VILLAGE WALK PHASE 4E REPLAT

Request for Minor Subdivision Plat to amend the preliminary plat for Village Walk Phase 4E.

Updated: November 25, 2013

Conformance with the Approved Master Plan

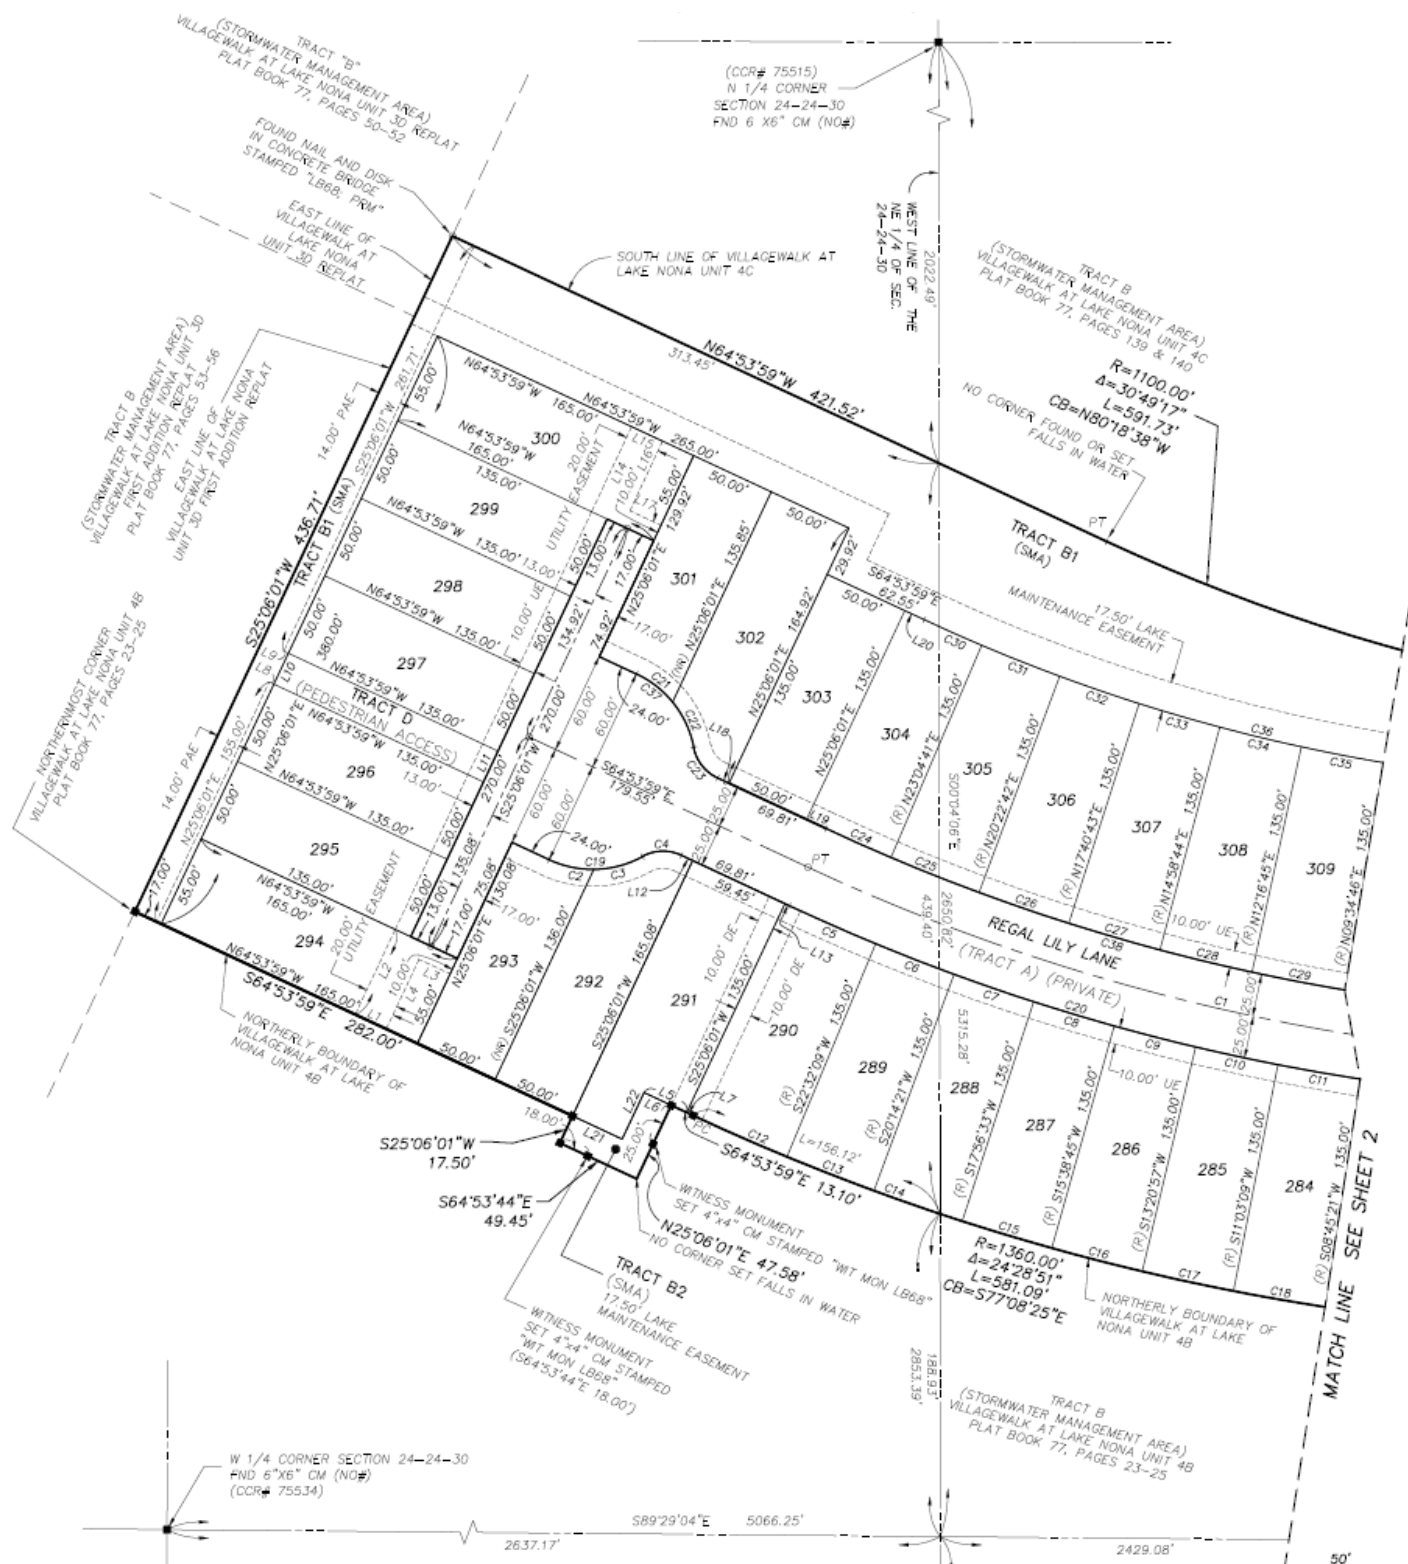
Per Case #LDC2012-00425, the proposed area can be either 50' or 60' lots.
